CITY OF ALBUQUERQUE

Re: 8009 Victoria NW
Request Permanent C.O. - Denied
Engineer's Stamp dated: 9-12-17 (E10D037)
Certification dated: 6-8-18

**Lots 12, Block 6
Volcano Cliffs Subdivision, Unit 5
GRADING PLAN**

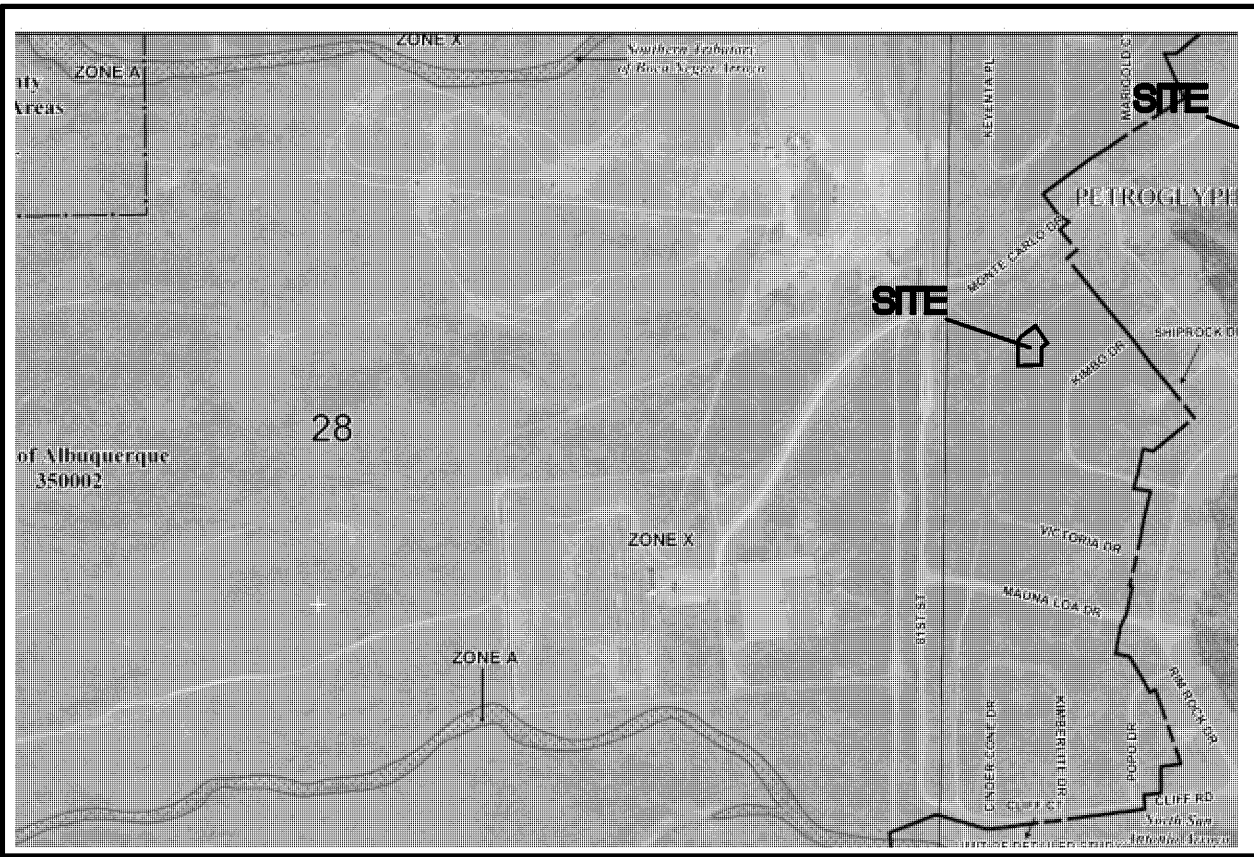
Based upon the information provided in your submittal received 6/7/18, this plan cannot be approved for Certificate of Occupancy until the following comments are addressed.

- Remove all concrete and debris in and around the site.
- Fill in the pond in the rear yard to its approved level.
- Remove the ditch in the rear yard. A 6" swale is sufficient.
